BOARD ACTION REPORT – APPEALABLE ITEM

Project Name: Kolter Hotel

Project Location: 135, 145, 169, and 185 SE 6th Avenue

SITE PLAN REVIEW AND APPEARANCE BOARD MEMORANDUM STAFF REPORT

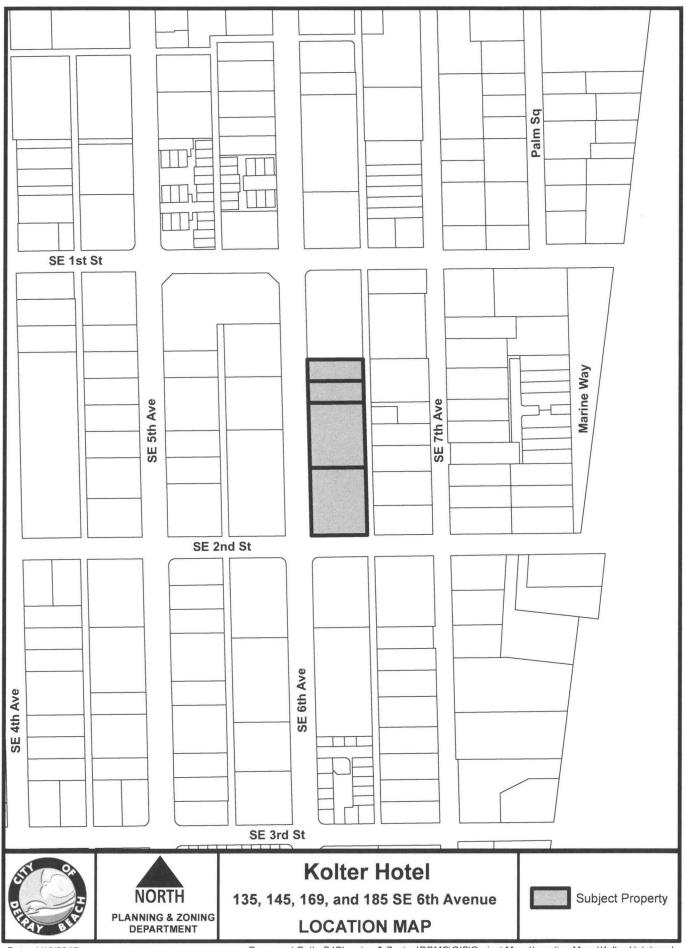
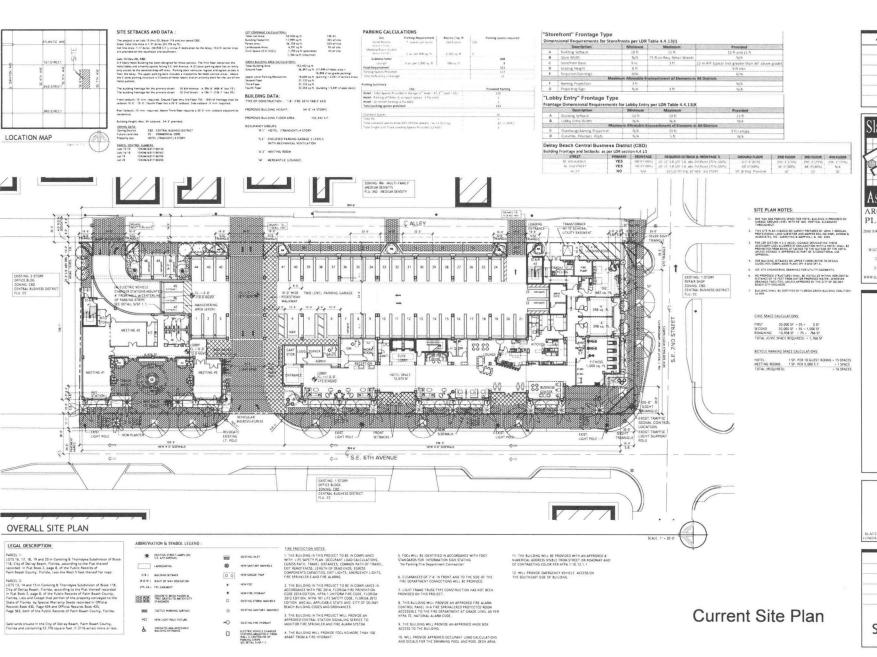
- 1. The final Landscape Plan reflects two-way access from Federal Highway.
- 2. A tree that offers more foliage such as Pigeon Plum, Magnolia, or Dahoon Holly be planted in the alley instead of a palm species.

SP1.0

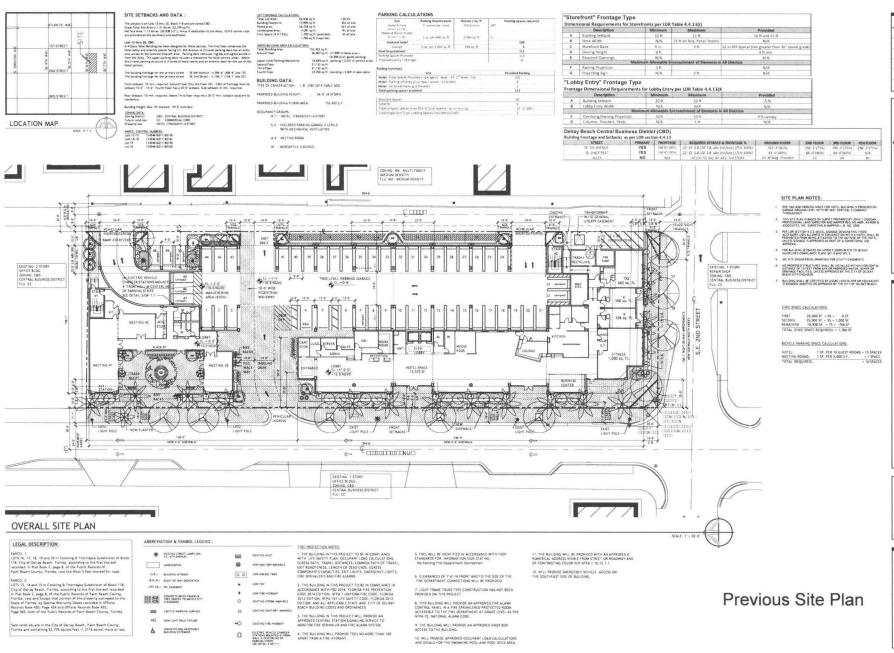
- 1. That the site plan be revised to provide parking facilities for a minimum of 16 bicycles.
- 2. That sufficient detail is provided to ensure the required pedestrian clear zone along SE 6th Avenue.

- 5. That the building façade proportions are correctly depicted to comply with Façade Composition Compliance;
- 6. That the kitchen ventilation is illustrated and adequately screened;

- 7. That the roof material is specified and compliance with the Urban Heat Island requirement is provided; and,
- 8. That the Green Building Practice requirements are noted on the site plan.

- 9. That the site plan be modified to establish ingress/egress to Federal Highway (if approved by FDOT) and associated changes to traffic circulation. That the traffic circulation shall be evaluated six months after Certificate of Occupancy by a professional traffic engineer. A report of the evaluation with recommendations to address identified issues (if any exist) shall be provided to the City's Planning Department within three weeks of the evaluation. The City shall review the report and provide direction to the applicant within 30 days of receipt regarding traffic circulation changes to address identified issues. The applicant shall make adjustments to the traffic circulation within 60 days of the receipt of direction from the City or as mutually agreed. The Marina Historic District shall be provided a copy of the report (upon receipt by the City) and a copy of the direction to the applicant prior to implementation of the recommended changes to traffic circulation (if any).

Current Elevation

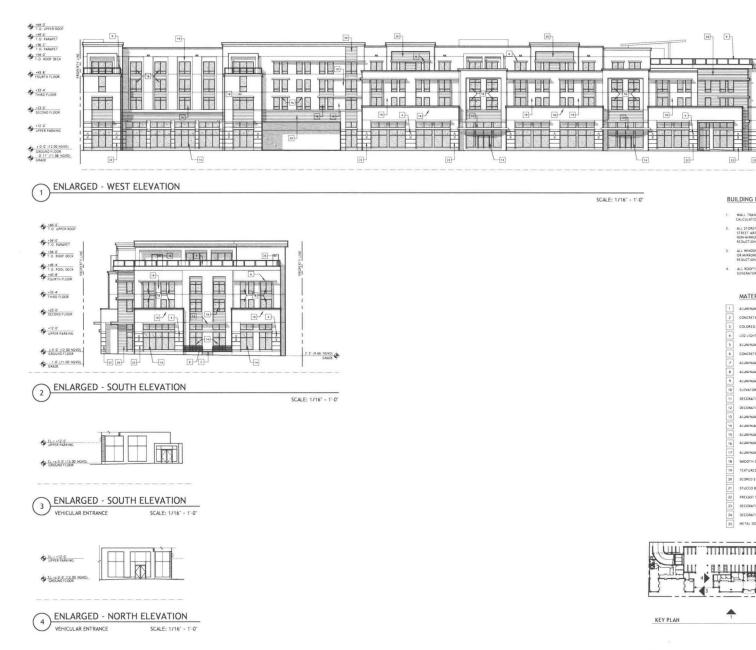
The applicant has revised the building elevations in response to the critique by the board, comments from the public, and meeting with staff. In the board package, the elevations presented at the January 25th meeting are labeled "Previous Elevation" and the elevations submitted for consideration at this meeting (March 22, 2017) are labeled "Current Elevations." The design maintains Masonry Modern architecture. Window proportions have been changed to be more vertical in proportion. Detailing provides more characteristics of the style, including deeper cantilevered eyebrows over windows and the incorporation of exterior spaces on the upper story. In discussions with staff, the material on the base was to be changed to precast material rather than stucco. However, the current elevations do not indicate the material

change discussed and shown in the renderings, so its application is a recommended condition of approval.
